Contract Number DAAK11-84-D-0016
Task Number 39

Rocky Mountain Arsenal

Offpost Remedial Investigation/Feasibility Study

Final Technical Plan
July 1988

Figure 1.4-1
 DIMP ASSESSMENT IN ALLUVIAL WELLS
 FOR CONSUMPTIVE USE-PHASE I AND II AND
 REVISION III-360° PROGRAMS
 SOURCE: ESE,1985c; ESE,1986b; ESE,1986c

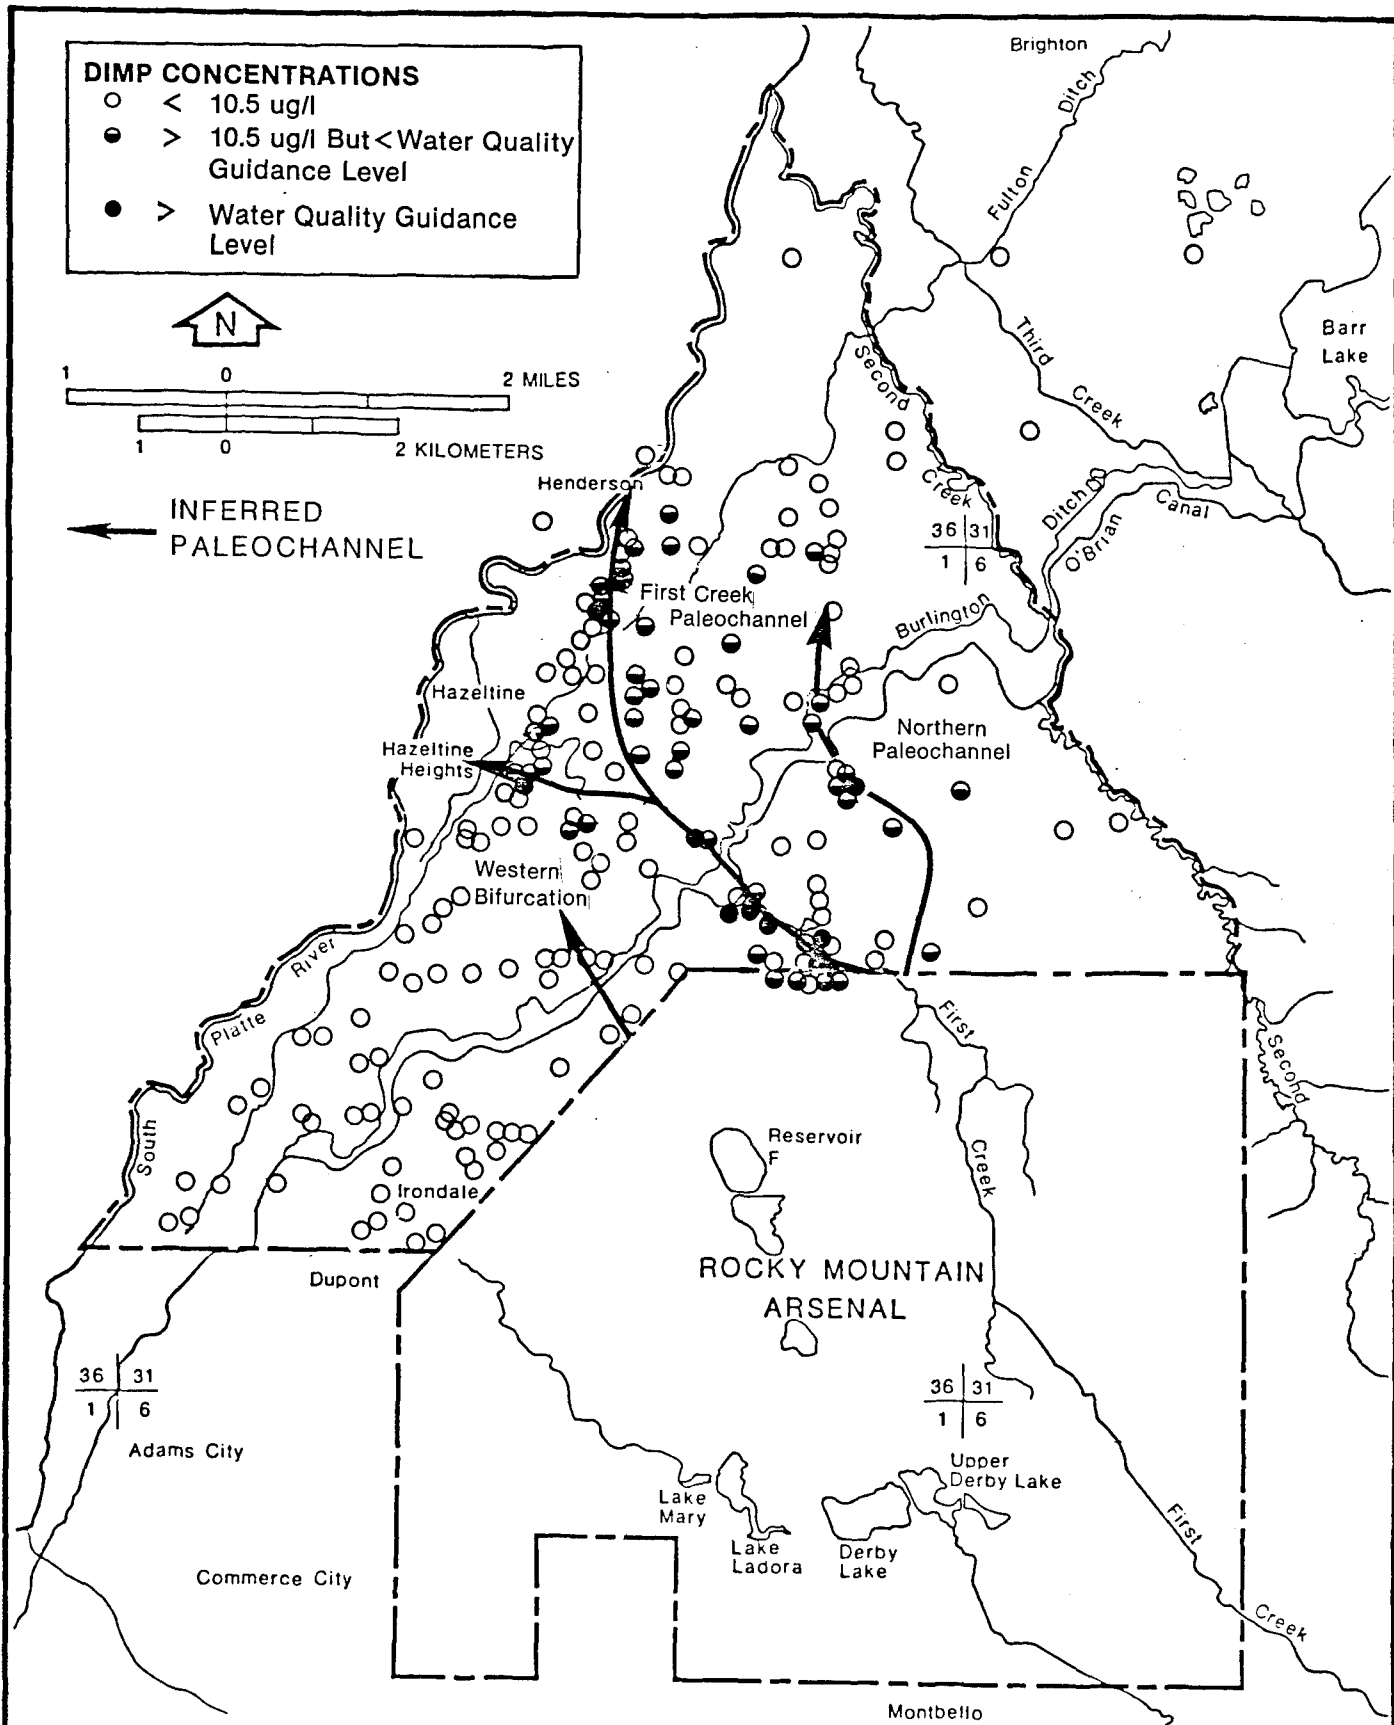
The detection limit for DIMP is listed as 10.0 ppb in the text but is listed as 11.0 ppb on Figure 1.4-1. Which is it?

Figure 2.1-1
 PROPOSED MONITOR AND BOREHOLE LOCATIONS
 FOR TASK 39

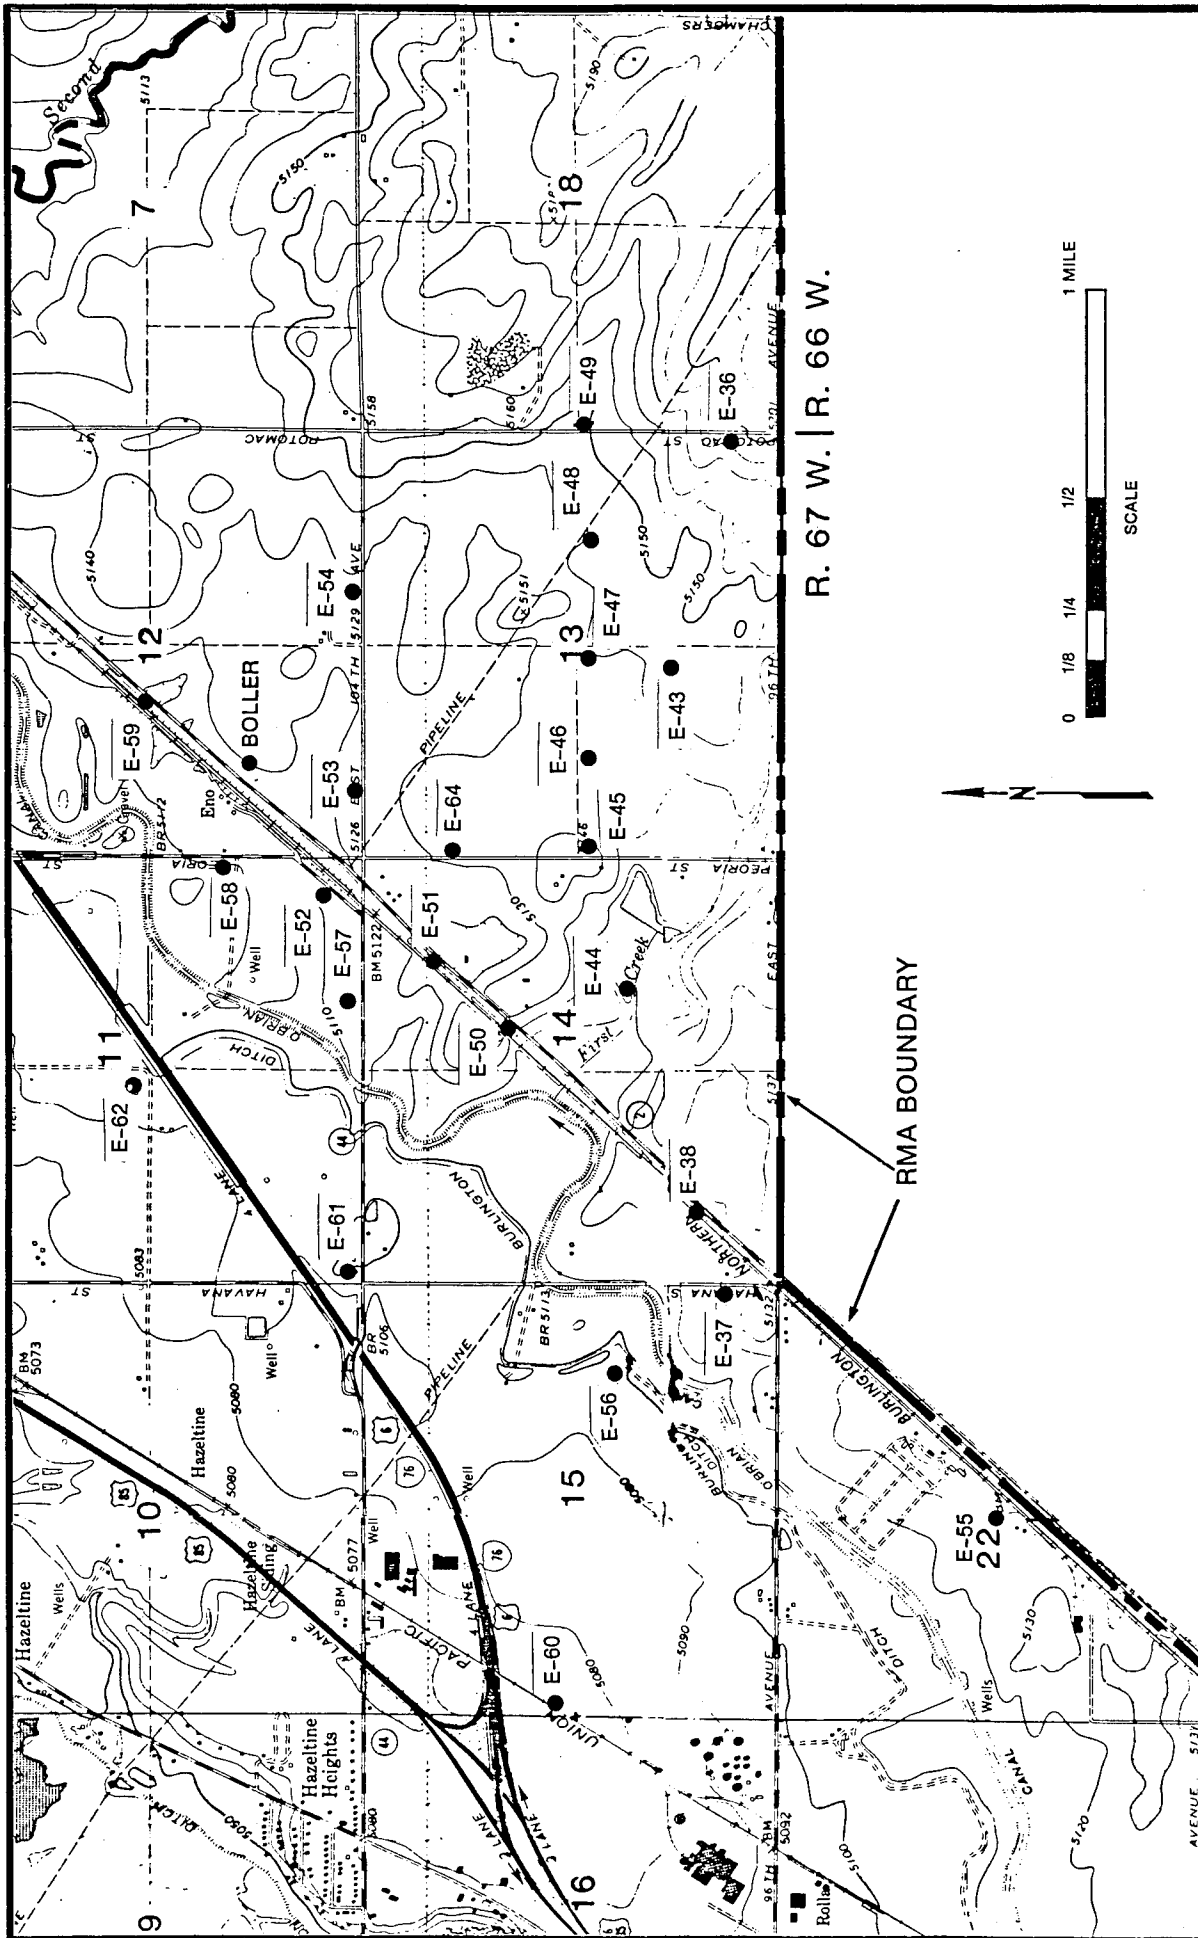
Comment 22: The location of the wells in reference to previous interpretation of the contaminant plumes and the top of the bedrock would assist the reader in understanding the logic to the location selected. Is there a well designated as E-37 located near the Boller's well in addition to the well labeled E-37 in this figure.
Page 2-2,
Figure 2.1-1

Comment 3:
Figure 2.1-1

Comment 7:
Page 2-2,
Figure 2.1-1

Response: The location of the Boller Well will be shown on Figure 2.1-1.

A well has been installed at Site E-55 and is shown in the Composite Well Drilling Draft Final Technical Plan. This well was initially considered a low priority well but was upgraded to high priority and installed under Task 25. No specific symbol is being used in Figure 2.1-1 to denote low priority wells. We are unclear as to which map is being referred to when 86946-01 is mentioned.

Figure 2.4-9
 SCHEMATIC DRAWING OF A
 TYPICAL CLUSTER WELL
 INSTALLATION

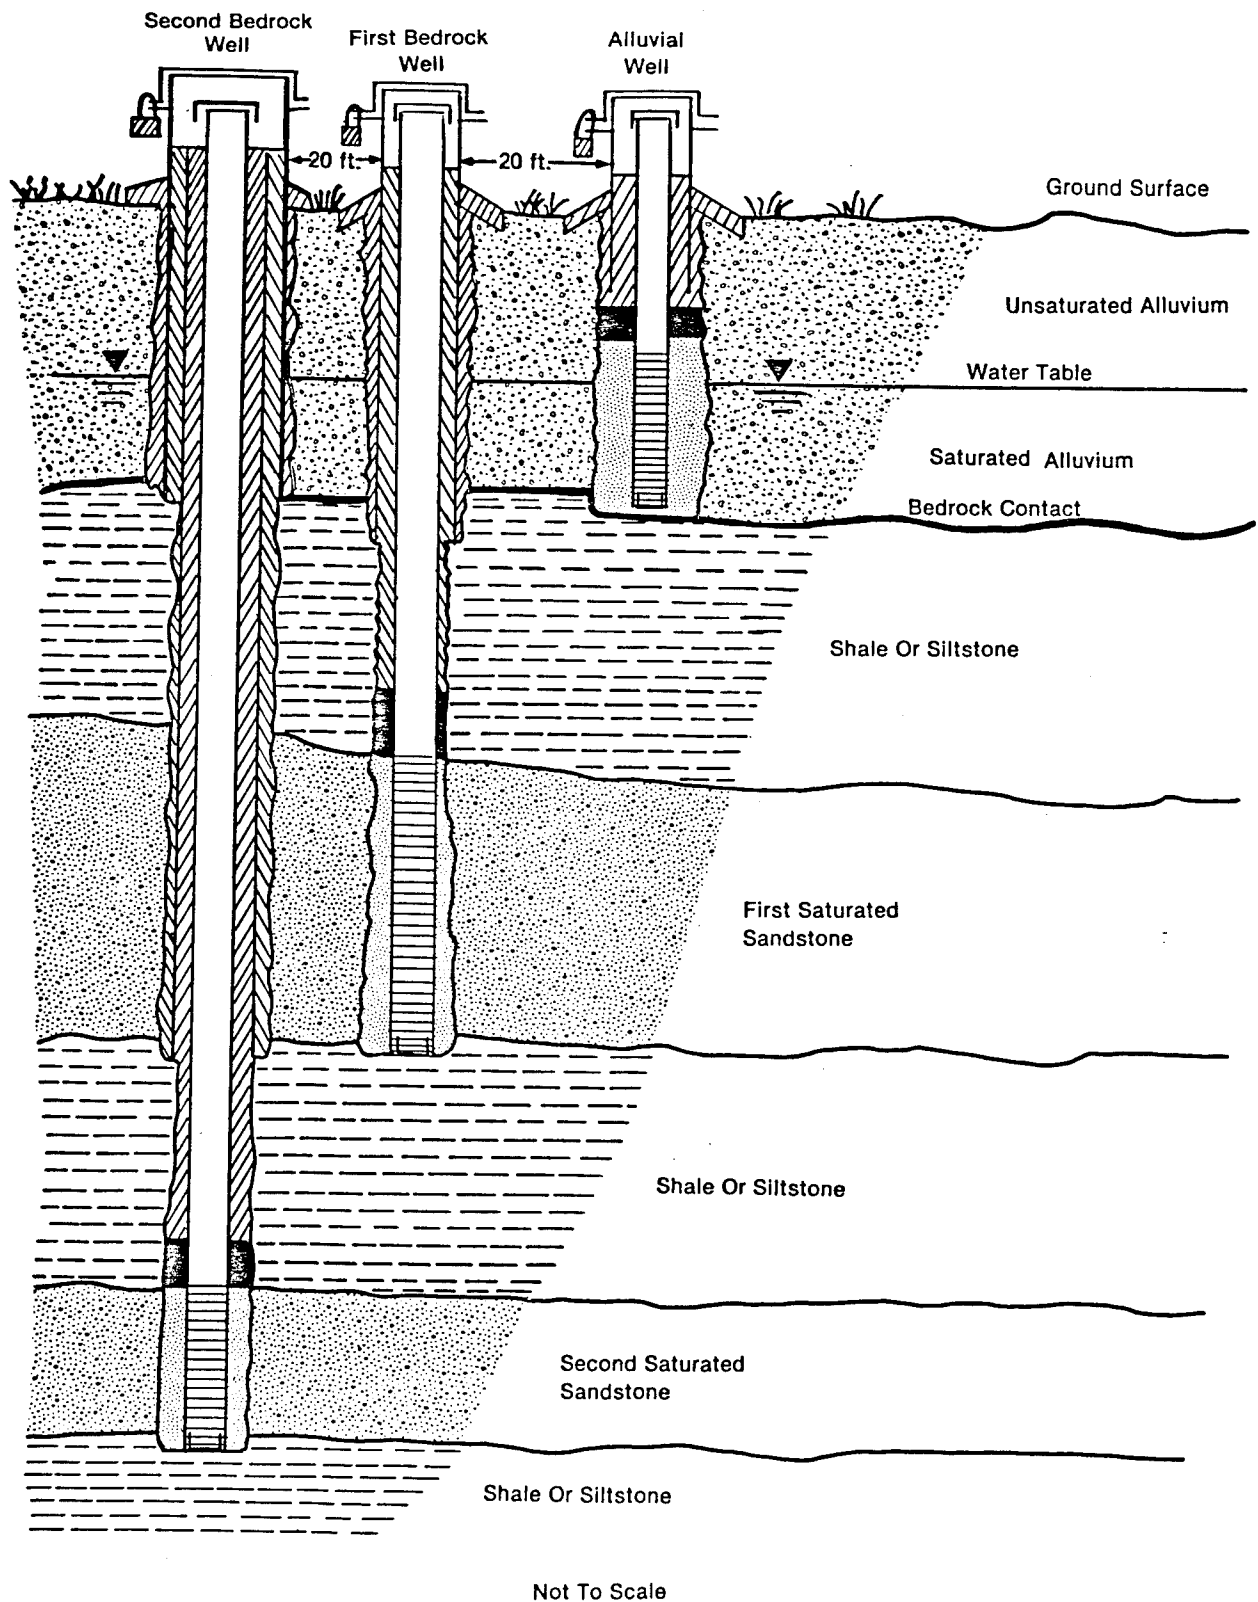
What is installed at the bottom of the casings in these wells? Are they capped? The screened interval should be labeled as such. Why are the cluster wells proposed to be 20 feet apart in Figure 2.4-9?
